Access Compliance Report

Public Rights-of-Way

(Curb Ramps)

Intersection ID: 53930	Main Street: STARNES RANDALL RD	Cross Street: BRITTONDALE LN	Location: SW
ADA ID: 97E74AD61D02	Ramp Type: Perp	Initial Pass/Fail: Fail	Overall Compliance: No
Severity Score: 18.75			
Codes/Mitigation Info/Possible Solution		Field Measurements/Component Compliance

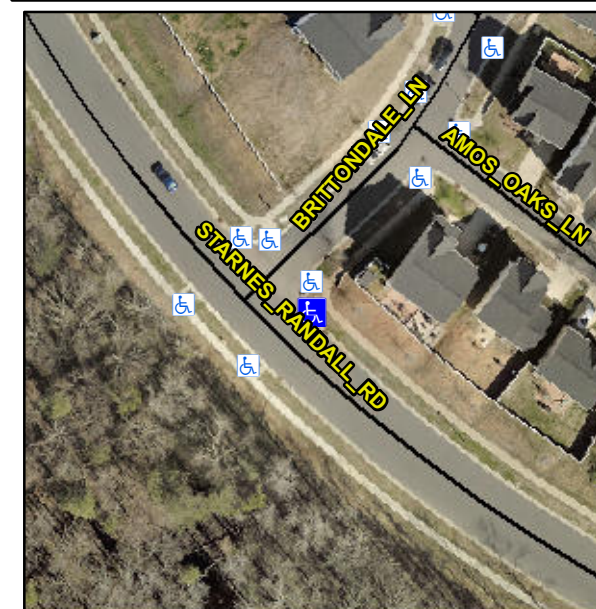
PROW/ADA:

Not Found, R304.5.1

Possible Solutions:

Remove & Replace Entire Ramp.
